Observation on a Strategic Housing Development application

313281

Barrington Tower SHD for 234 Built to Rent Apartments in 8 blocks with associated entrance, parking, siteworks, services and landscaping, etc.

Planning & Design Review

Development Plan 2022 – 2028**12.3.5.2 Separation Between Blocks**

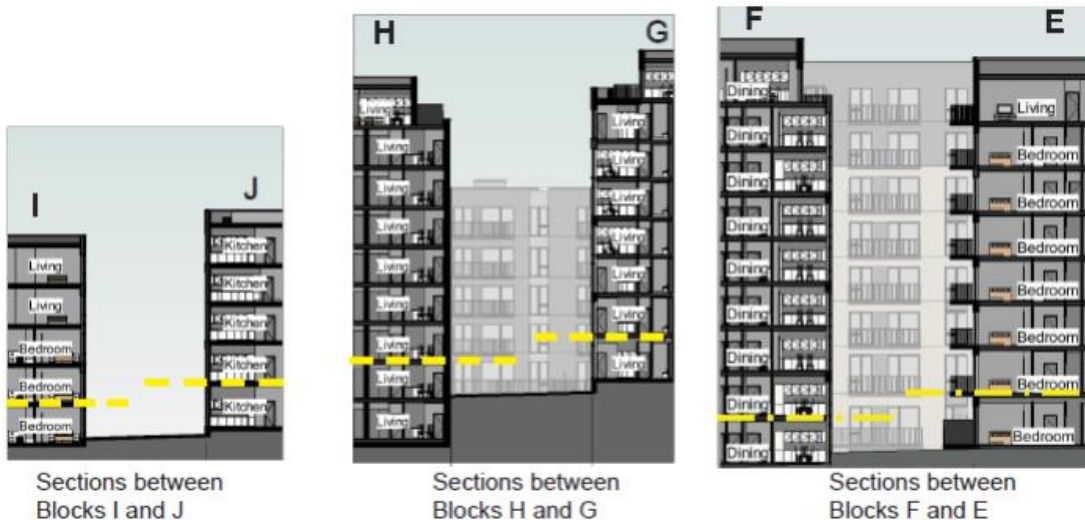
*A minimum clearance distance of circa 22 metres, in general, is required, between opposing windows in the case of apartments up to three storeys in height. **In taller blocks, a greater separation distance may be prescribed having regard to the layout, size, and design.** In certain instances, **depending on orientation and location in built-up areas**, reduced separation distances may be acceptable. In all instances where the minimum separation distances are not met, the applicant shall submit a daylight availability analysis for the proposed development*

There seems to be no “Material contravention” comment to cite in Chapter 11 of the applicant’s Planning Report. However, in Chapter 9, P. 123, the Planning Report states that “Finally, it is noted that, contrary to Section 8.2.3.3(iv) that some of the separation distances between blocks are less than 22m.”

Section through Peter Cassidy Architects model looking eastwards towards the development.

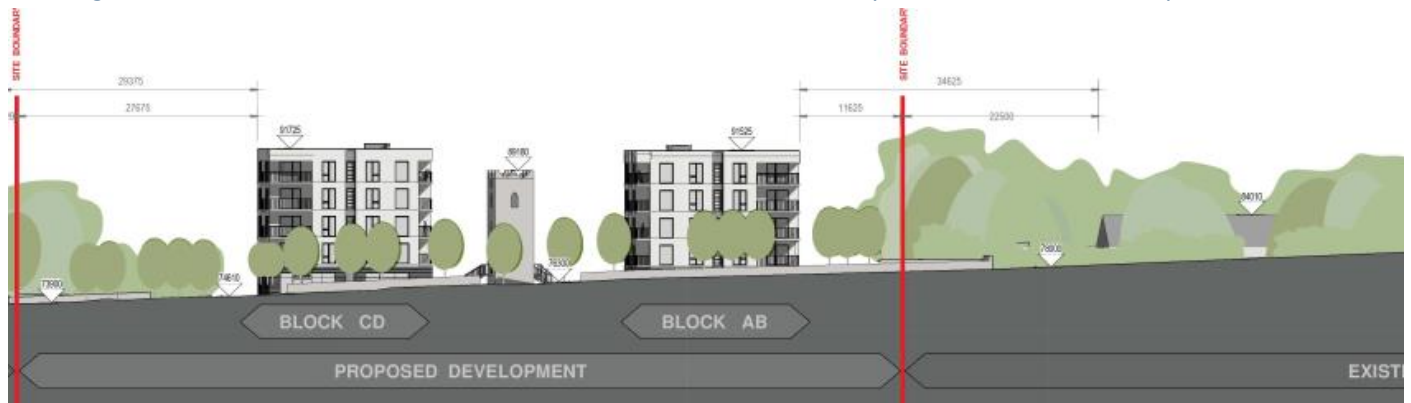
Then, we compared this with a section through our approximate model – without the trees – to see the scale of the proposed development relative to our client's house. The concept of "having regard to the pattern of development in the area" is used to assess proposed developments. The proposed development ignores these existing patterns.

Extract from the Applicant's proposed Section AA looking south from Brennanstown Road.

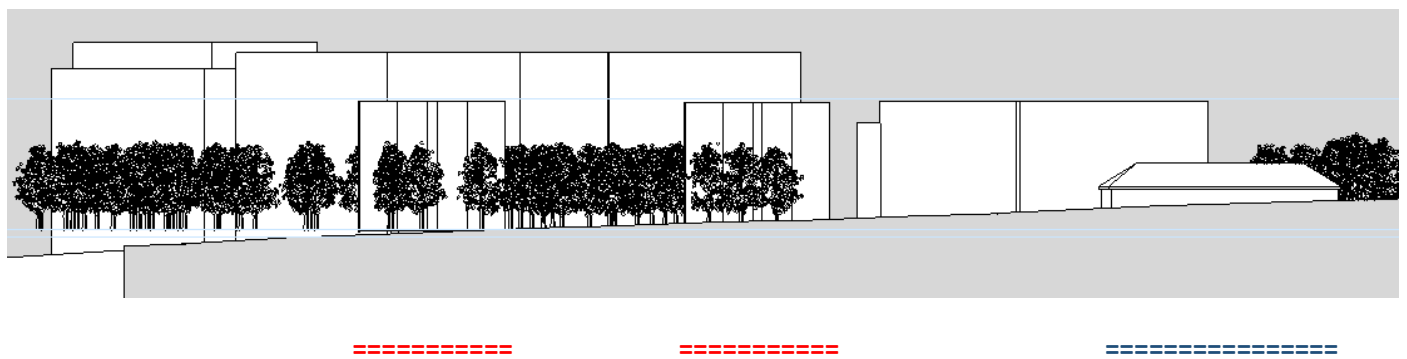
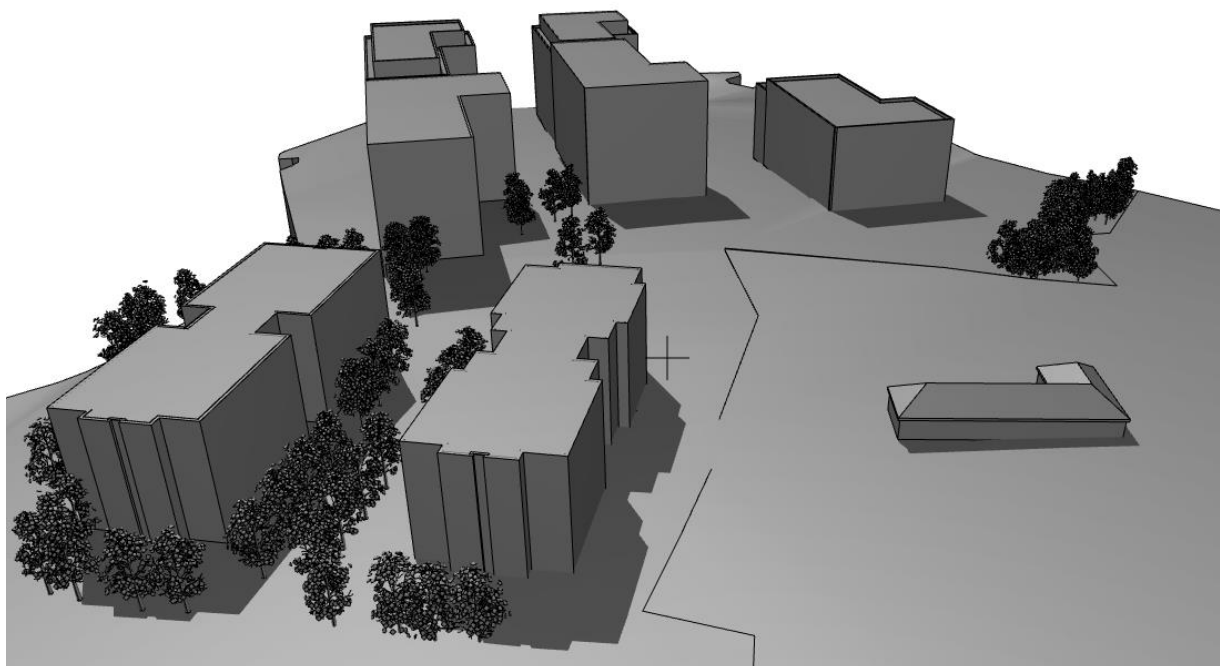
We then looked at Section AA which includes our client's property, but with so many trees that our clients house is difficult to make out amongst the greenery. The submitted artistic rendering by the applicant is of a development which proposes to remove the existing screening trees which the Development Plan requires to be maintained. However, the developer continues to show mature trees in their sectional elevation, copied below. Also, this drawing omits the outline of the blocks further back in the site to better present the lower, front pair of blocks.

As you can see from the above section the effect of the blocks further away is disproportionate. With the screening effect of the trees removed, the effect is striking and shows how the existing dwelling is dwarfed and overlooked. The effect is very clear when looked at in the 3D aerial view. We therefore request An Bord to refuse permission.

The applicant has provided a Daylight Sunlight and Overshadowing Report from which we extracted these examples

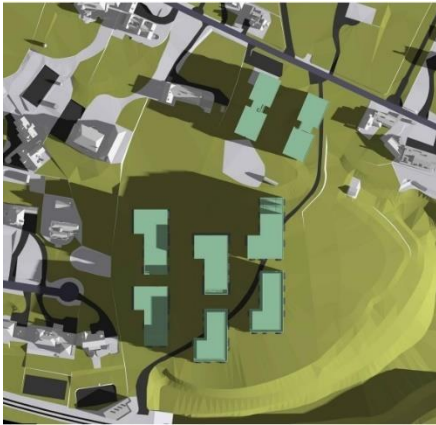
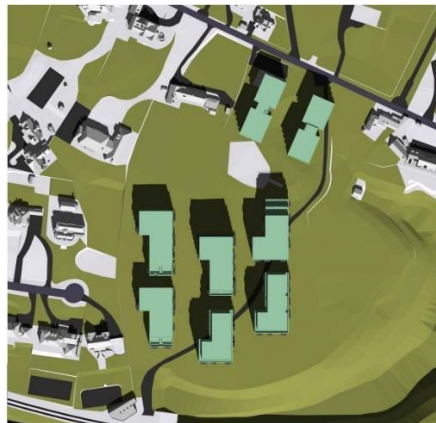
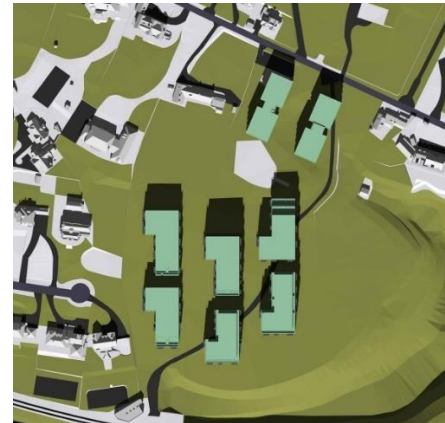
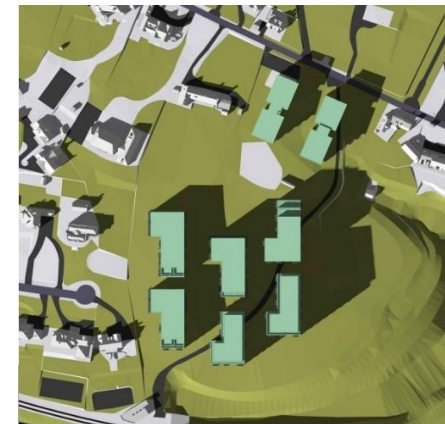
These shadow studies show the proposed development on March 01 at the times shown at the bottom of each image from 0800 to 1700.

Diagram 32 Fire appliance (high reach) access to buildings

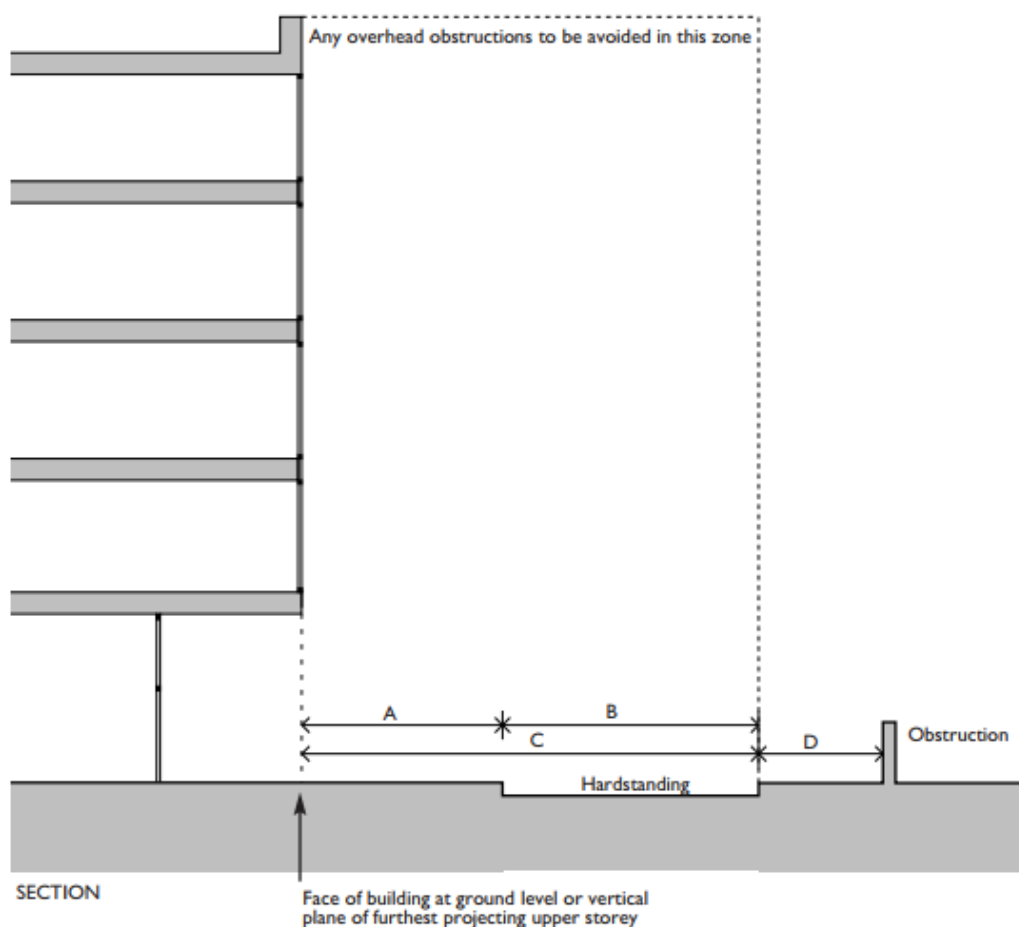
The Applicant has shown a 4.8 M wide main access road and a 3.6M wide road along part of the western boundary. There are no turning facilities apart from T-junctions and it is not clear that these provide sufficient access to enough of the block's perimeters to comply. There appears to be no hard standing within 2.0M of the building per Dia. 32.

- The internal layout of the development is not in compliance with the requirements of Section 5.2.4 of Technical Guidance Document B, with regard to turning facilities for the Fire Service. It is considered that the proposed development would endanger residents by reason of fire safety and therefore would not be in accordance with proper planning and sustainable development in the area.

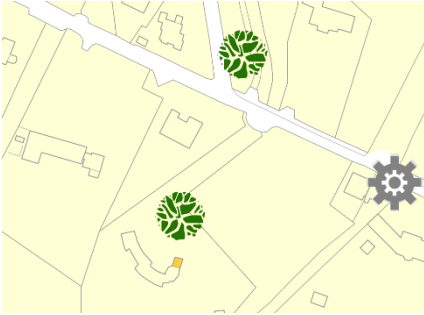
We submit that this development exceeds the prescribed height of three stories whereby 22M separation distance is considered acceptable by two to seven stories. We submit that this low-density area of predominantly single-storey and two storey houses cannot be considered to be one of the “built-up areas”. We therefore submit that the proposed development would materially contravene this requirement of the Development Plan, which is intended to ensure that the primary land use zoning objective is met. The daylight report shows that these blocks, due to the limited distance between them, their excessive length and height will cause overshadowing of the Communal Open Space (COS), resulting in a poor quality external environment. We submit the COS will suffer from tunnel-effect high winds from the prevailing wind direction and significant downdrafts due to the height of the buildings.

Figure 8 Bike Collisions

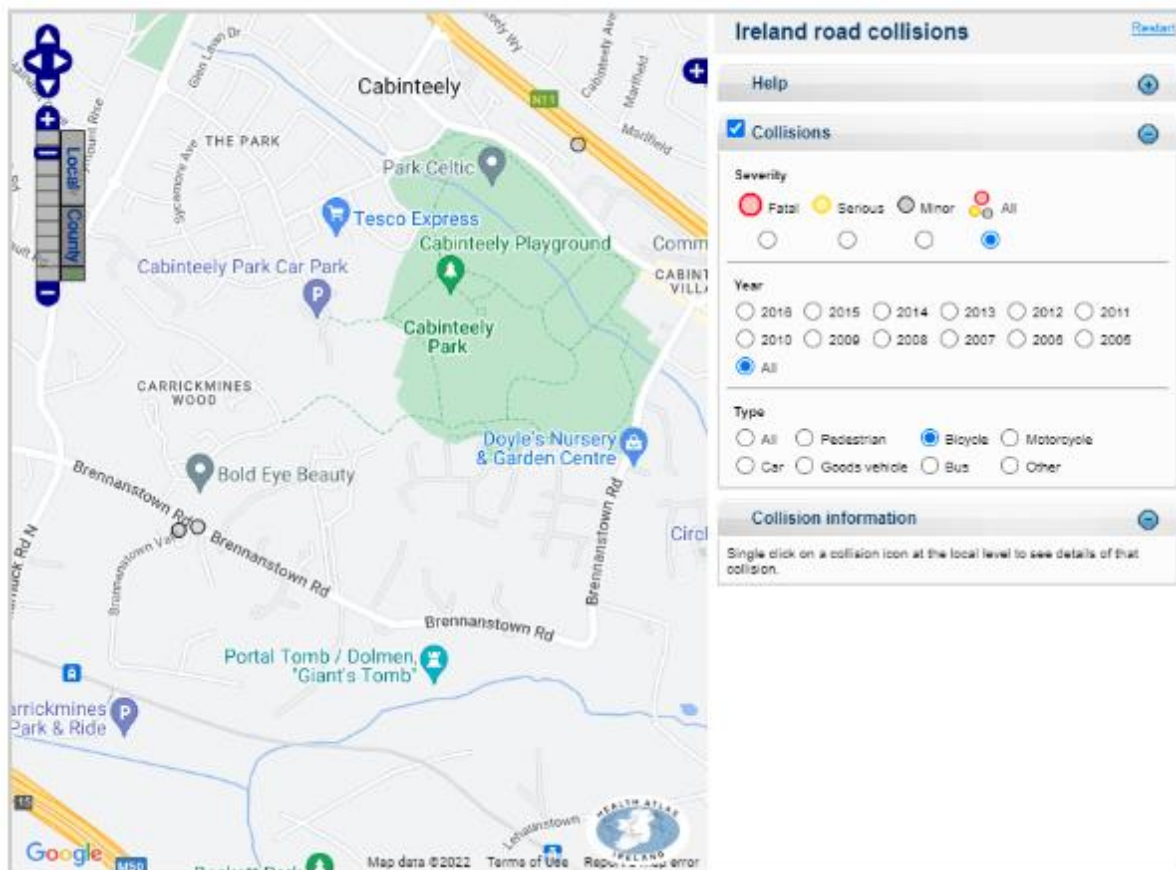
The above image shows a cyclist approaching a bend in the road with forward visibility less than what is acceptable for the speed limit. This may, as evident in the RSA collision data, lead to collisions with vehicles as there is not sufficient reaction time to break upon encountering a cyclist on the road.

Figure 4.52: Extract from the National Cycle Manual (2011) which illustrates the appropriate use of integrated or segregated cycle facilities according to the volume and speed of traffic.

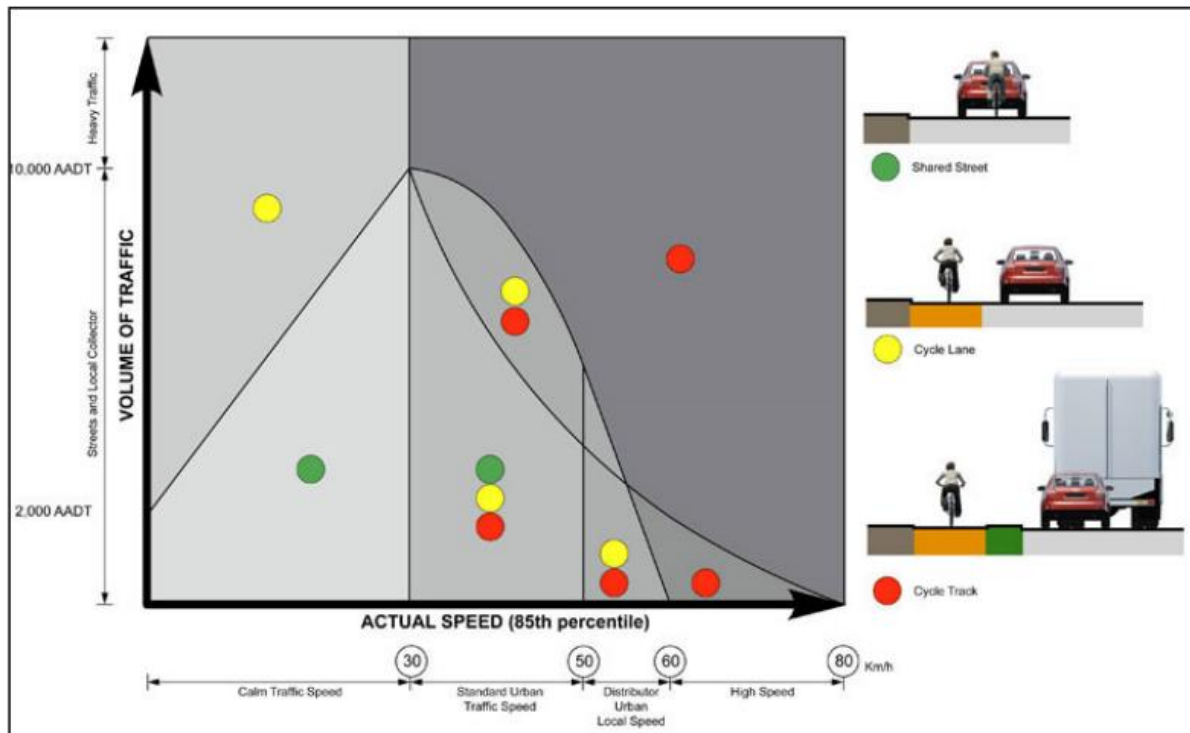
Using figure 10 below, there is a requirement for an off-road cycle track to ensure the safe passage of cyclists along Brennanstown Road.

The Applicant acknowledges the sub-standard nature of Brennanstown Road and its unsuitability to cater for the proposed development. The Applicant further acknowledges that Brennanstown Road will not be subject to a Part VIII scheme by the Local Authority but is instead reliant on Third Parties to deliver critical infrastructure for the development both in terms of road safety and sustainable transport.

To permit the development in its current form would be premature pending the construction of the road improvement works on Brennanstown Road that are required to support this application and already permitted developments.

Figure 12 Traffic Congestion – Brennanstown

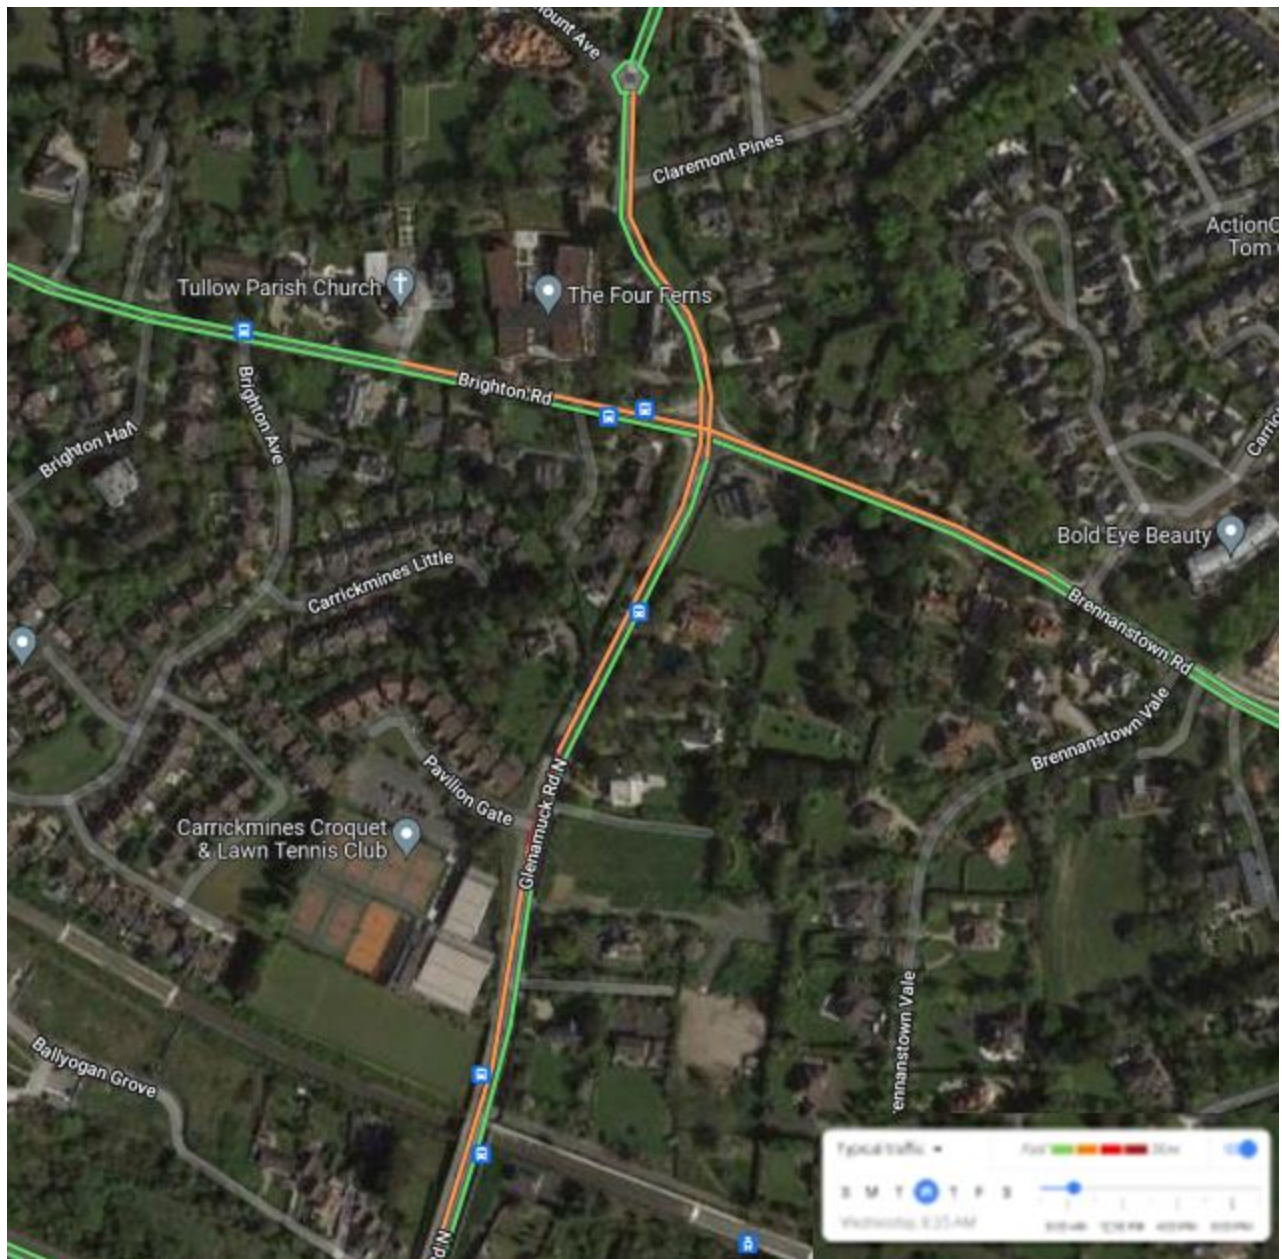
Anodically, and based on Google Maps Traffic layers, the queues from the Junction 1 can stretch back along Glenamuck Road measuring c. 510m, on Brighton Road measuring c. 165m, on Cornelscourt Hill Road measuring c. 210m and on Brennanstown Road measuring c. 360m.

Junction 1, as modelled by the Applicant, shows an increase of 14.76% in the AM and 10.16% PM with a max que of 25 on Glenamuck Road North. Assuming one car equals 5m, the queue length illustrated below is c. 101 which is less than what is indicated on the Google Map extract.
